Planning & Zoning Commission Staff Report

Meeting Date: April 3rd, 2024

Description: **Manors at Lynstone Park Improvement Plans** – A request for the approval of Improvement Plans to construct a 9-lot single-family home development on property zoned R-6.

Figure 5. Proposed Development Layout

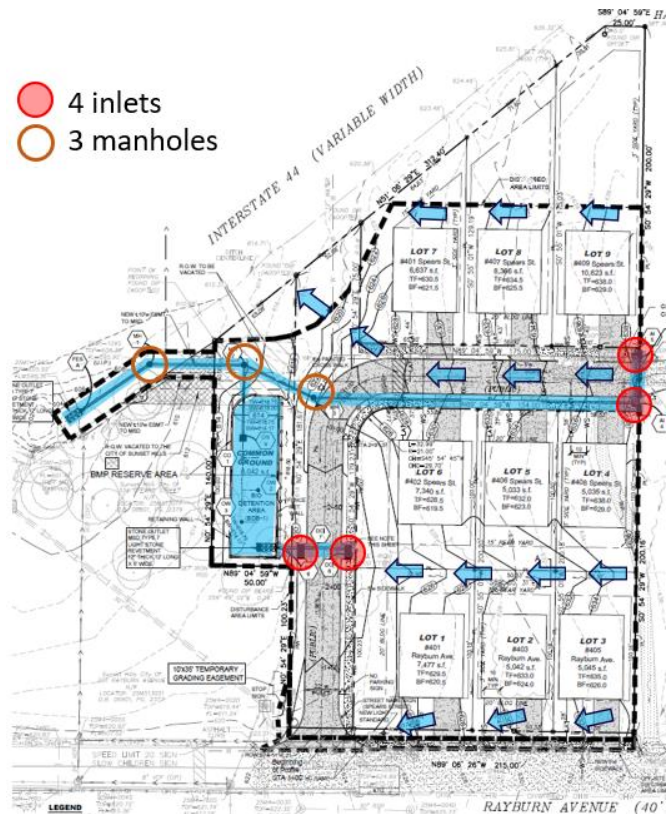
City Code states all paving shall have a minimum width of twenty-six feet (26'), unless otherwise approved by the Planning and Zoning Commission. The internal road is proposed at 22' wide as depicted on the approved Preliminary Plat and will connect to an existing road (Spears Street) that is a variable width and close to 18' wide at the connection with the future road. Provided the road is 22' vs 26', on street parking will be prohibited and the applicant will install a "No Parking" sign at the entrance to the development.

A five-foot-wide sidewalk is proposed along the internal roadway and Rayburn Avenue. A new streetlight is proposed at the corner of the proposed roadway and Rayburn Avenue meeting the City Code requirement.
